ADDENDUM NO. 2

April 7, 2022

COLONEL JOHN WHEELER MIDDLES SCHOOL ADDITION, RENOVATION, AND RELATED WORK
Crown Point, IN 46307

SHEET
C-4.0

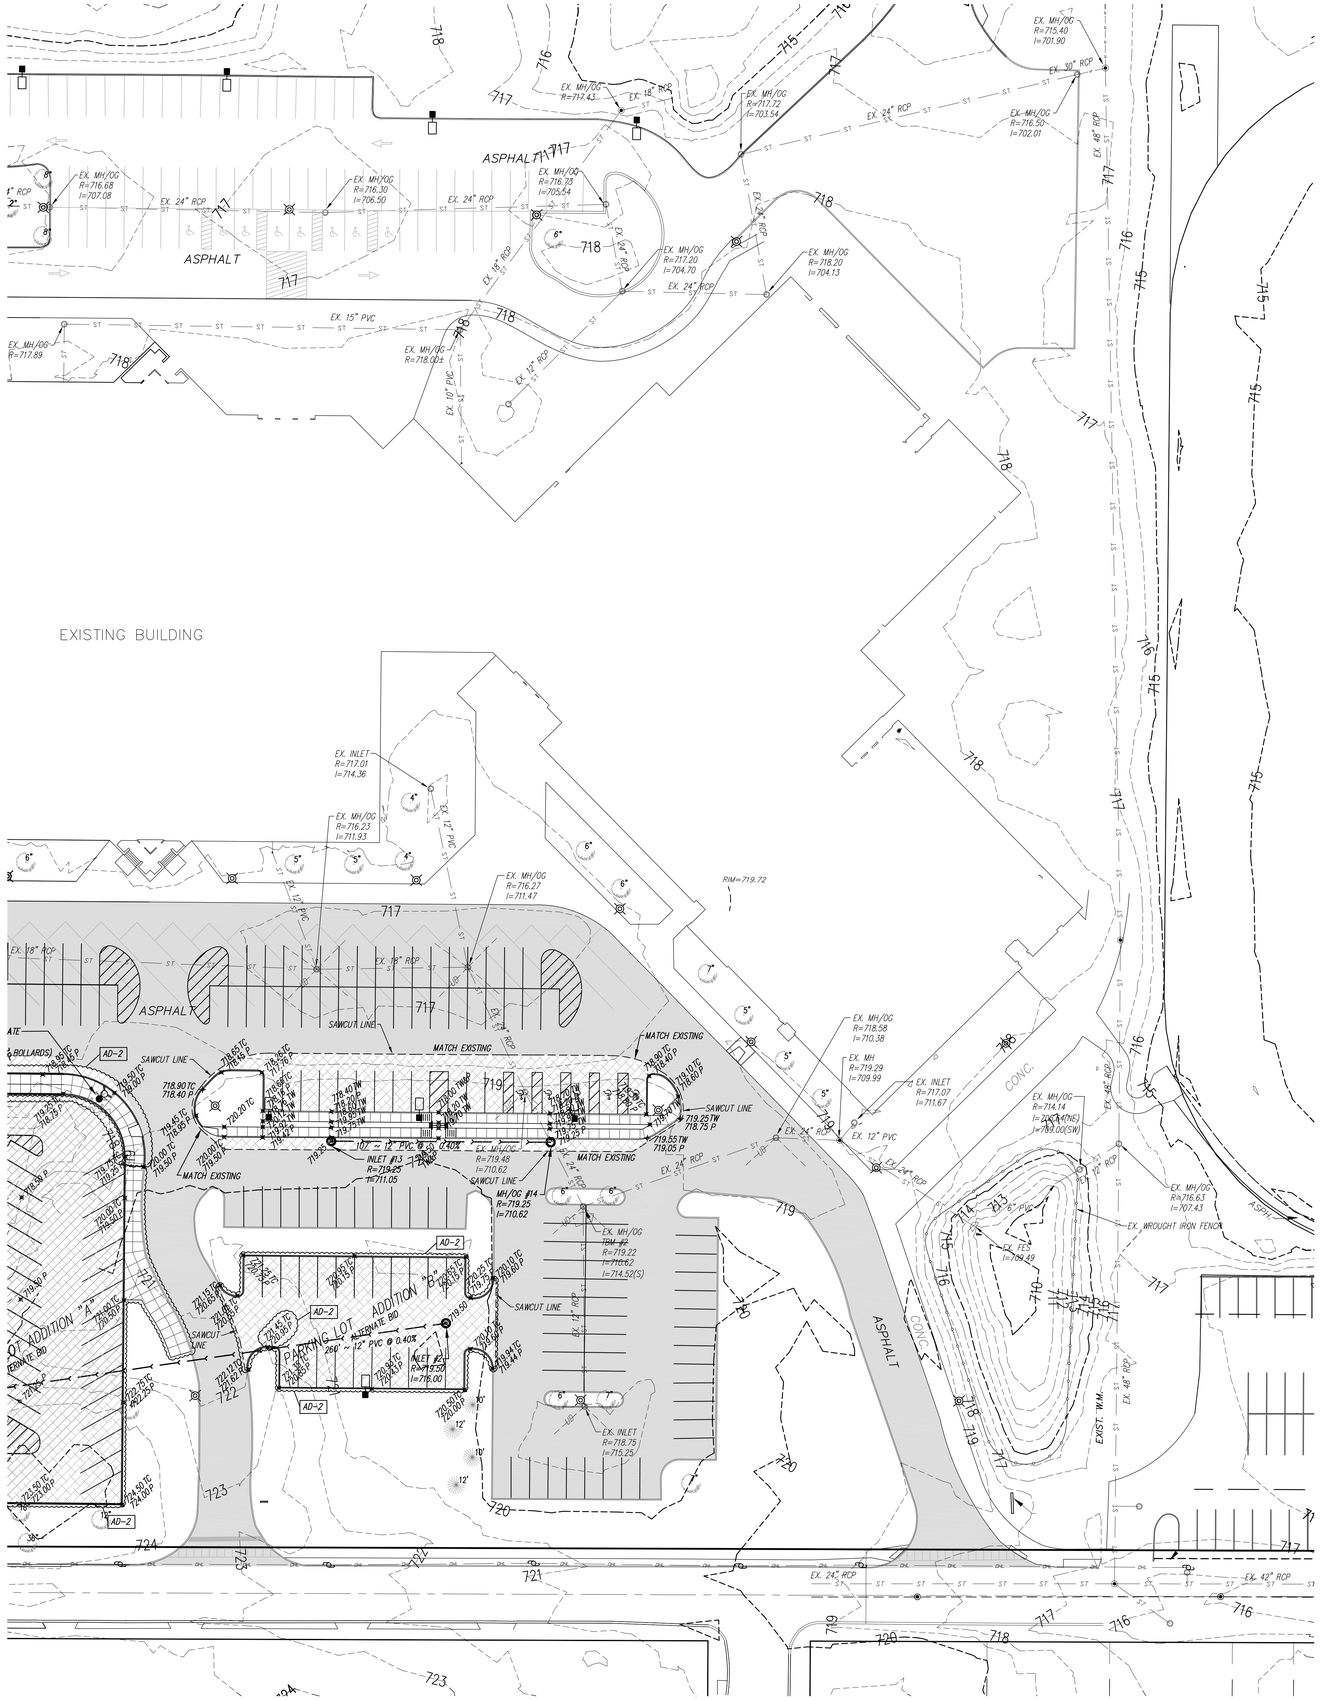
1. The additional sidewalk and handicap ramps are shown with the necessary elevations. A new 6-foot sidewalk has been added to the north side of the proposed addition. This is part of the Base Bid. Parking Lot "A" and Parking Lot "B" are to be included in Alternate Bid #1.

SHEET
G
S-202

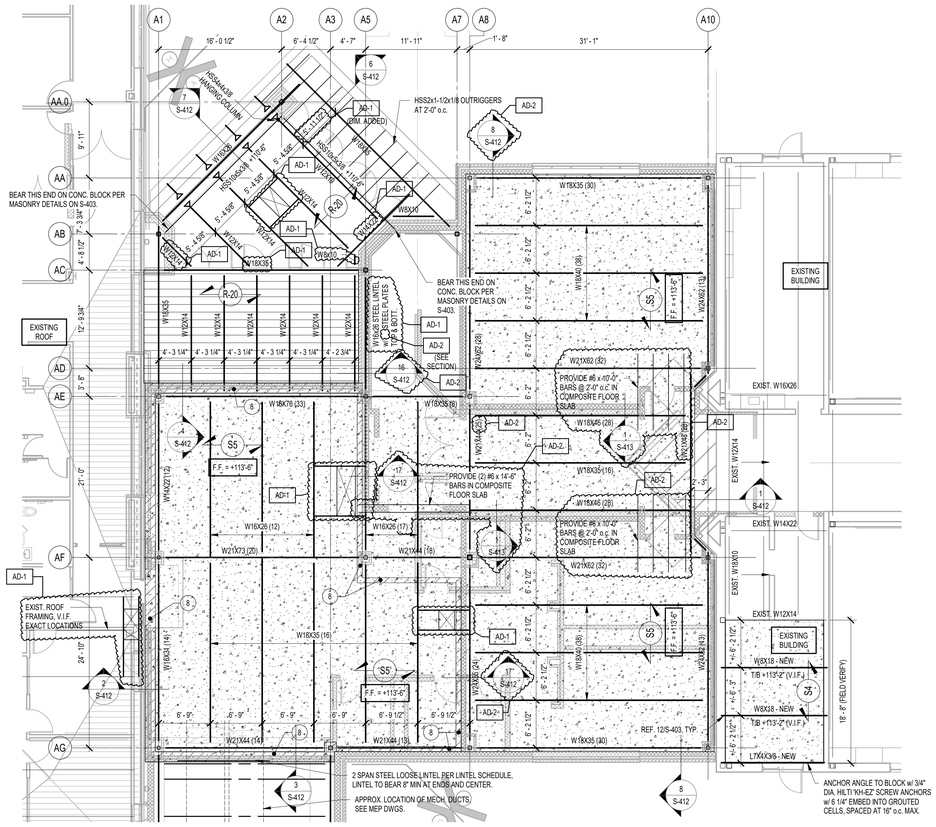
1. Sections/Dimensions added for clarity

UNIT "D" ARCHITECTURAL FIRST FLOOR DEMOLITION PLAN

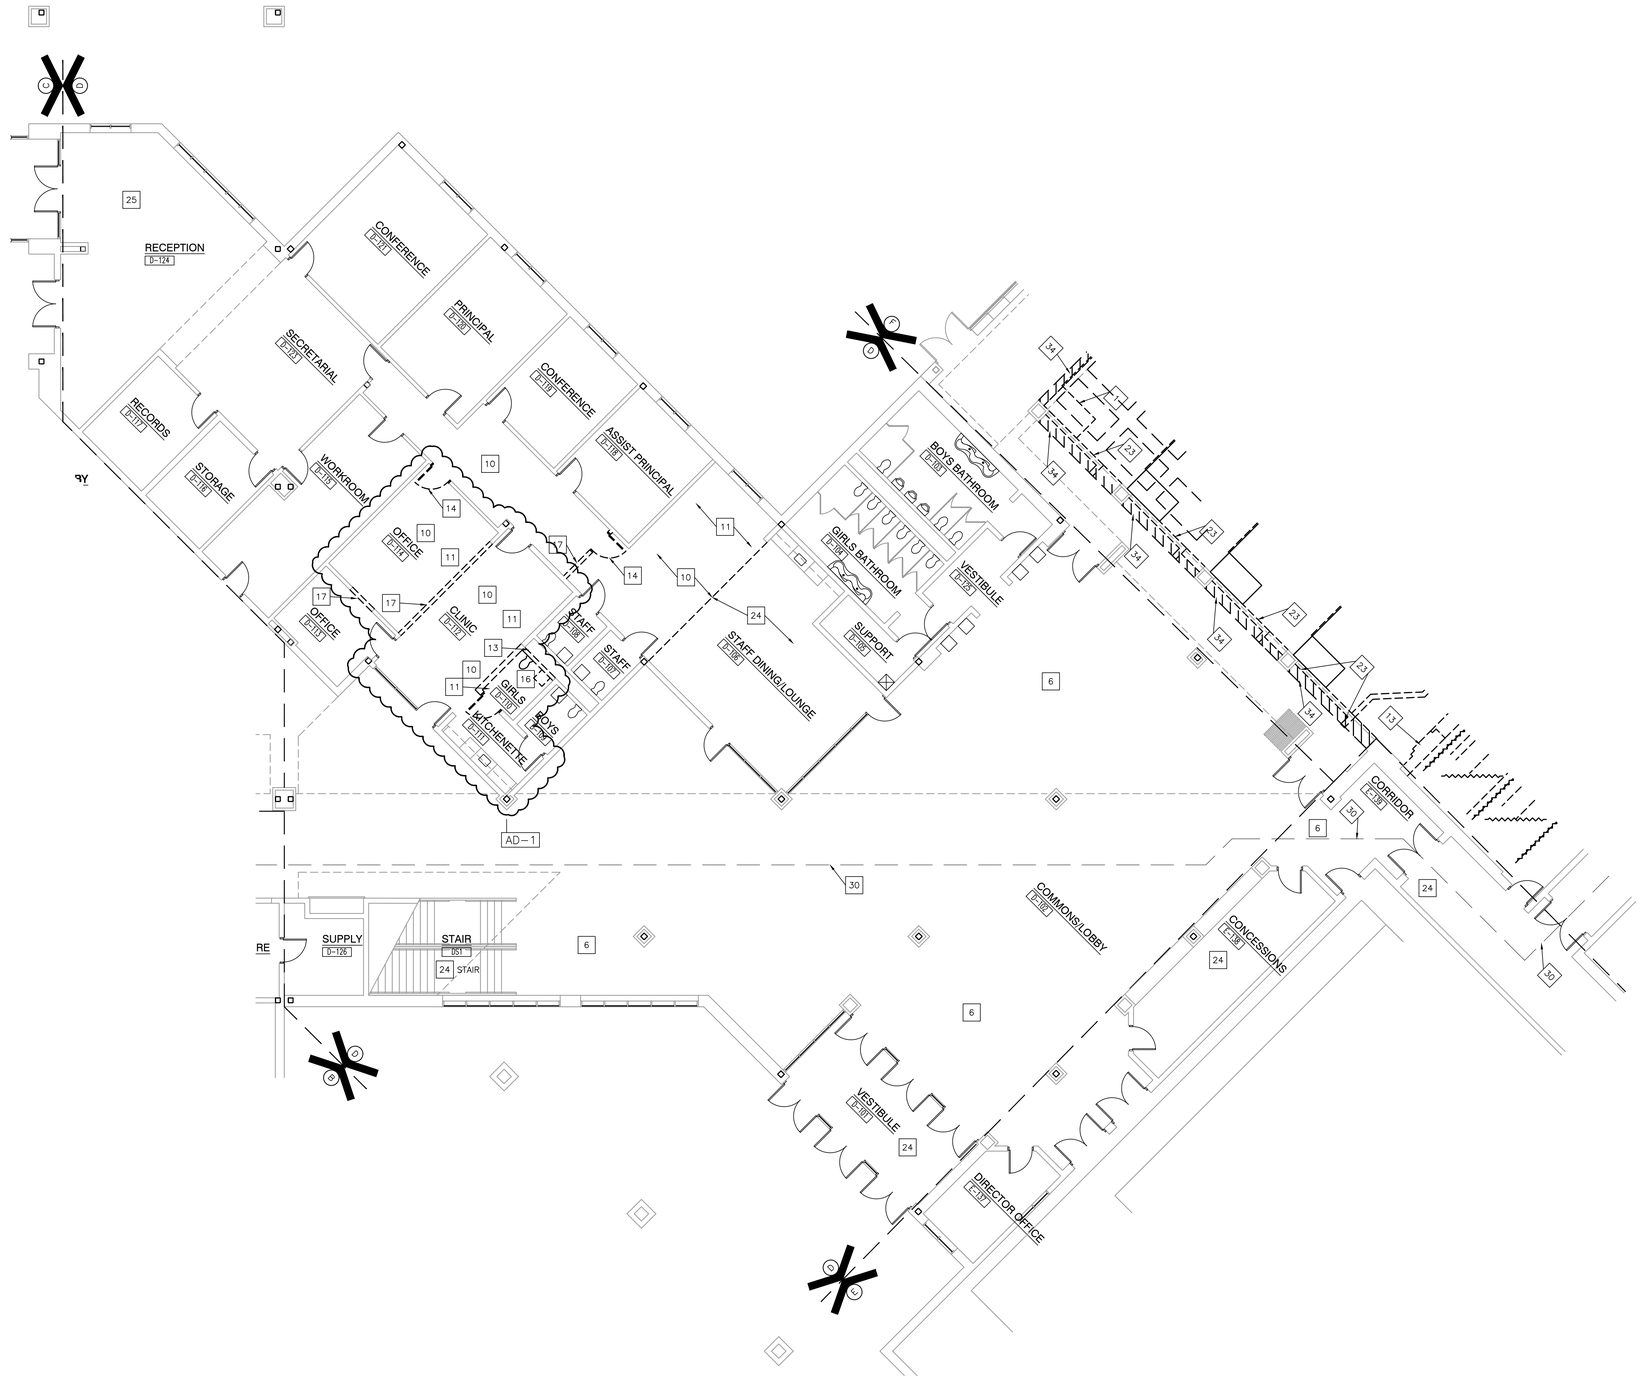
1. Revise Demolition Plan Note 5 to read "5. DEMOLISH WINDOW SYSTEM COMPLETE."
2. On sheet AD-105, clarified area of demolition to the railing system west of Corridor B240.
3. On sheet AD-108, added demolition note #13 in two areas.
4. On sheet AD-111, added clarifying note to remove steel beam as part of proscenium demolition.
